ADDENDUM NO. 6

City of Chattanooga
Moccasin Bend WWTP Secondary Clarifier Upgrades
Contract No. W-14-006-201
For Bids Due: September 1, 2016, 2:00 pm (Addendum No. 3)

ADDENDUM INSTRUCTIONS

| ATTACHMENT NO. A630A | BY RWW | SECONDARY CLARIFIER UPGRADES MOCCASIN BEND WASTEWATER TREATMENT PLANT | | CONTRACT NUMBER W-14-006-201 | SHEET 1 OF 2 |

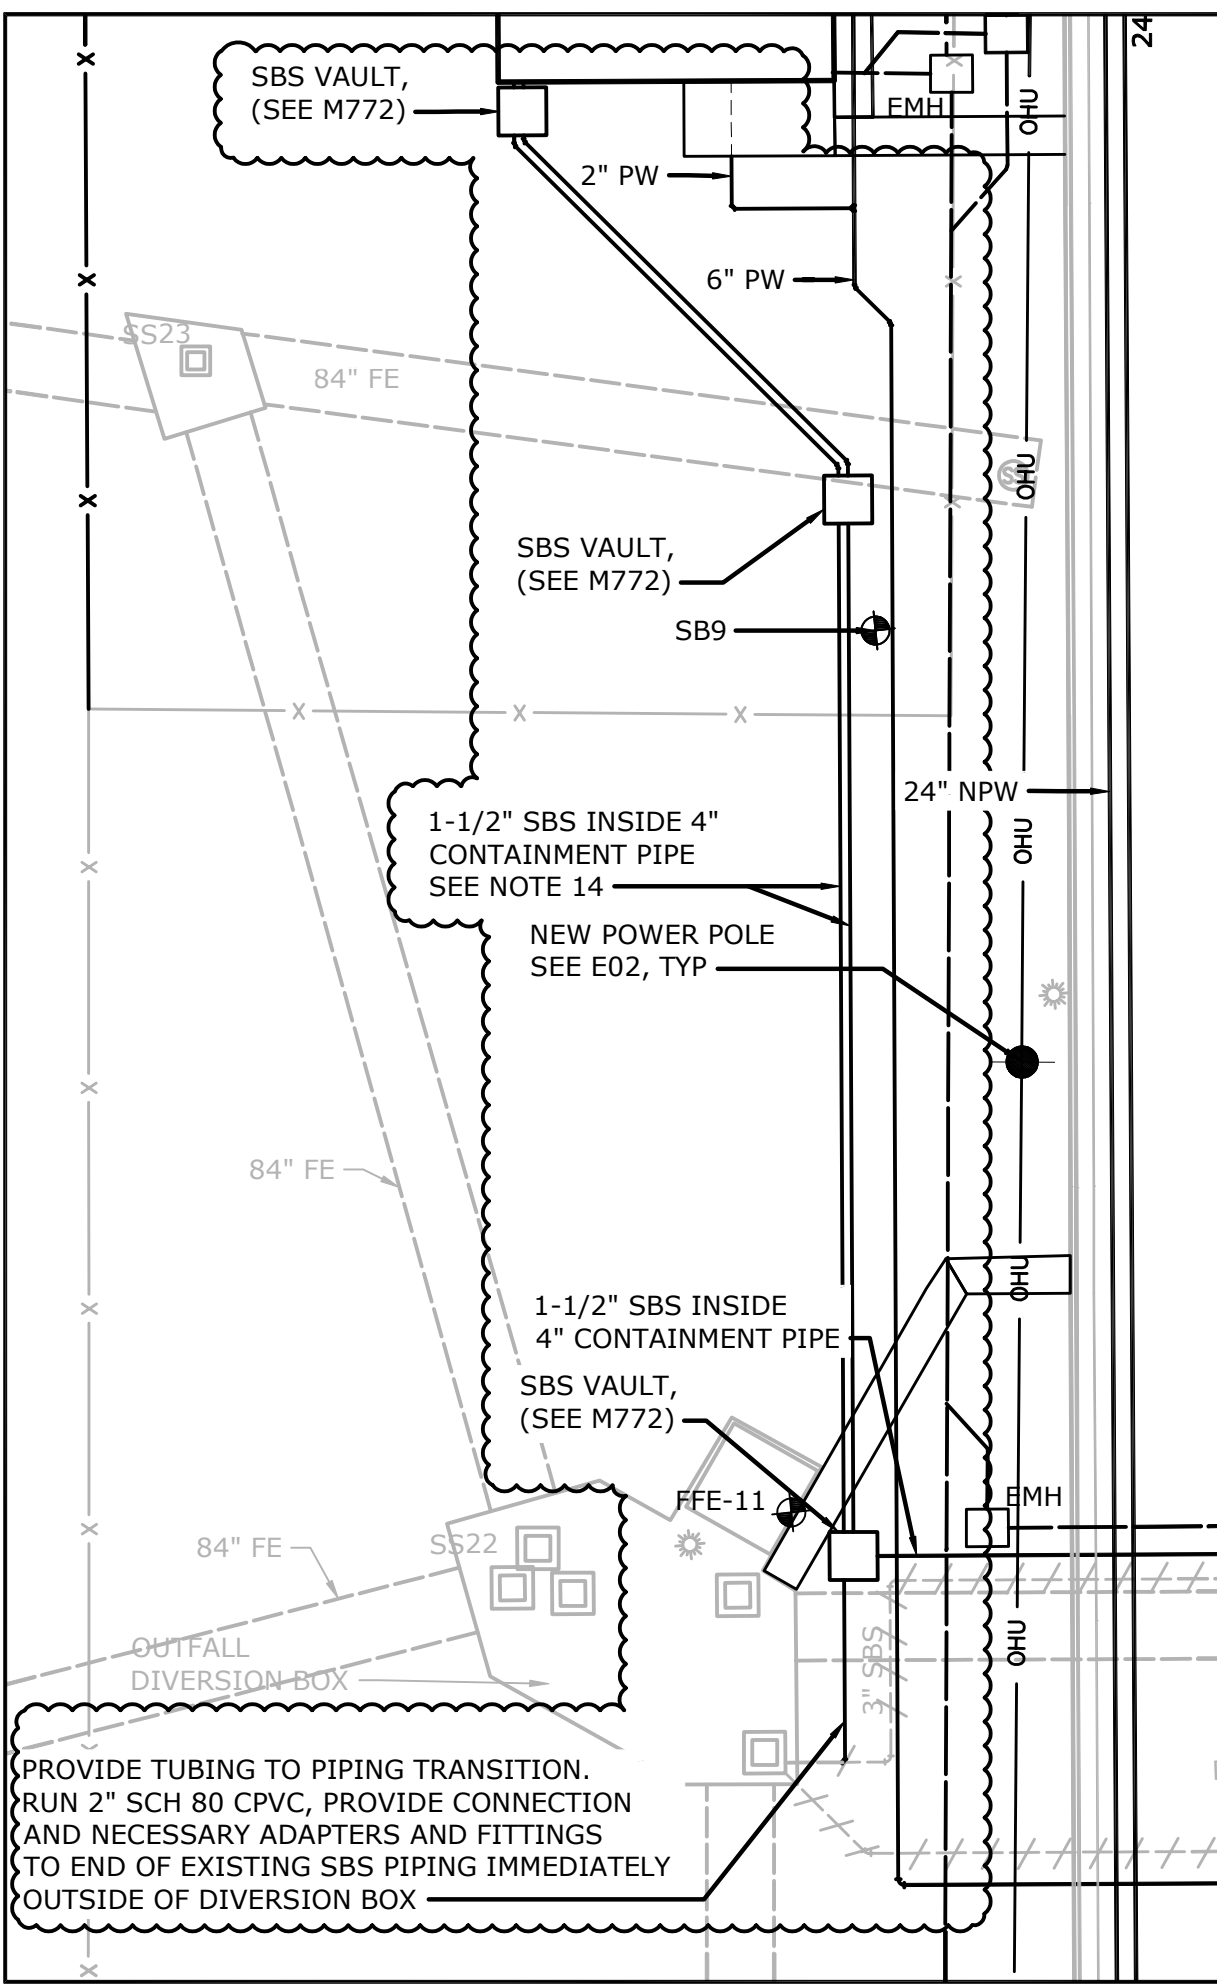
5. DRAWING C30
 - A. Modify vault locations and piping alignment as shown in Attachment A6C30A and A6C30B of this Addendum.
 - B. Note 13. Add the following to the end of the note: “INVERT ELEV AT SOUTH END APPROX 651.02 AND AT NORTH END APPROX 649.87.”

CLARIFICATION: New SBS pipe will be connected to existing SBS pipe just outside of Diversion Box as shown in attachments to this Addendum.

| ATTACHMENT NO. A6D22A | BY RWW | SECONDARY CLARIFIER UPGRADES MOCCASIN BEND WASTEWATER TREATMENT PLANT | CONTRACT NUMBER W-14-006-201 | SHEET 1 OF 1 |

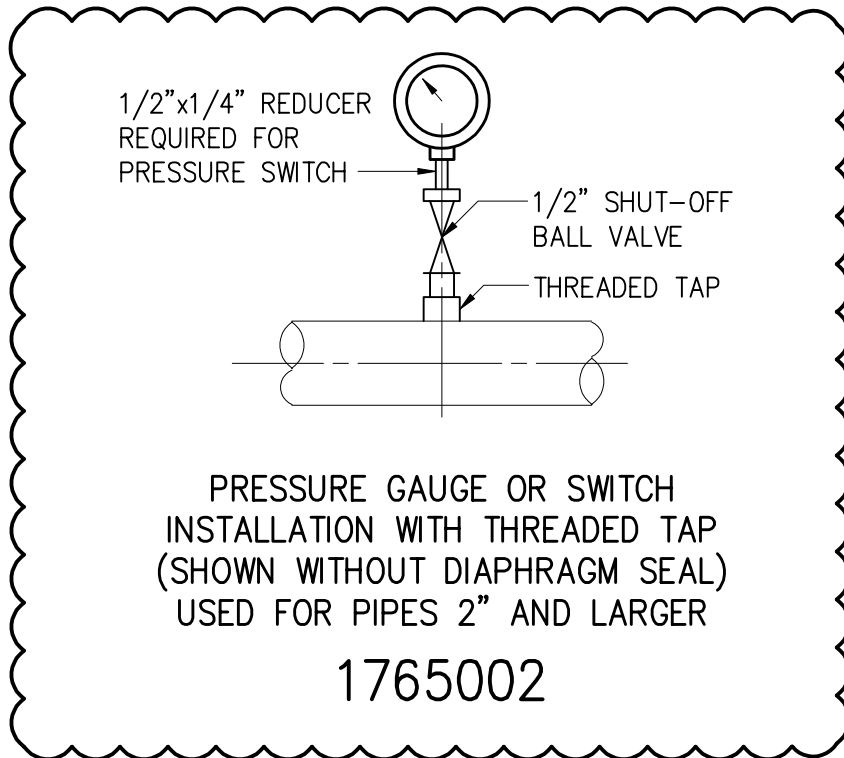
- B. Change Diameter of all 2-1/2” SBS Transfer Pump Piping to 3”.
12. DRAWING D22
- A. Add Standard Detail 1765002 attached to this Addendum.

7. QUESTION: Plan Sheet M504 labels Standard Detail 1765002 as being typical of each discharge pipe directly downstream of the flow meters. Please provide this Standard Detail.

CLARIFICATION: Detail 1765002 is included as an attachment to this Addendum.
